Errata document

[Document Name]
V850E2/Sx4-H Hardware User's Manual [Preliminary]

[Document No.,Date Published]
R01UH0107EJ0001 (Rev. 0.01), February, 2011

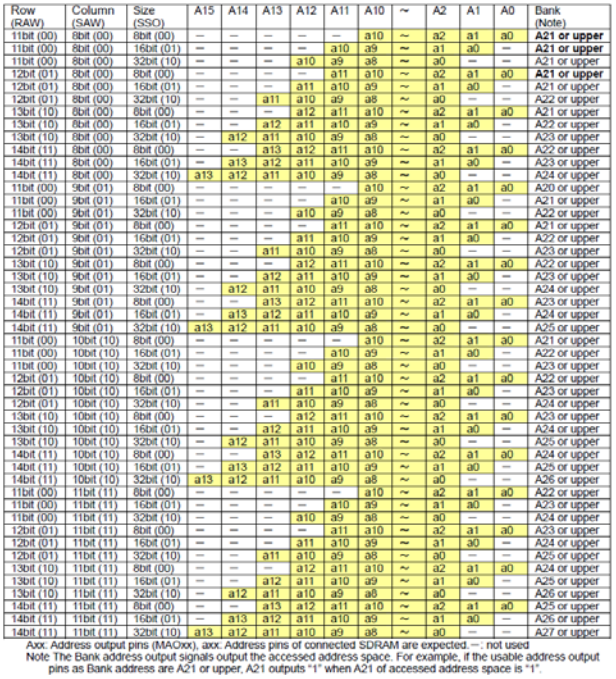
p.227	Chapter 4 External Memory Controller (MEMC)	Addition of 4.2.11 SDCR - SDRAM configuration register	Added: Cautions 6 Please write only once in SDRAM configuration register after reset release.After writing, please do not change the value.When changing the value, it is can't normally access any more in SDRAM.
p.236	Chapter 4 External Memory Controller (MEMC)	Addition of 4.3.2 SDRAM bus cycle type	A connection list to SDRAM by address bus is given in the tables below.

Axx. Address output pins (MAOxx), axx. Address pins of connected SDRAM are expected. —: not used Note The Bank address output signals output the accessed address space. For example, if the usable address output pins as Bank address are A21 or upper, A21 outputs "1" when A21 of accessed address space is "1".
p.326	Chapter 6 DMA Controller (DMAC)	Modification of Table 6-2 DMA start sources	Modified: "INTADC0I0" -> "INTADCA0I0", "INTADC0I1" -> "INTADCA0I1", "INTADC0I2" -> "INTADCA0I2"
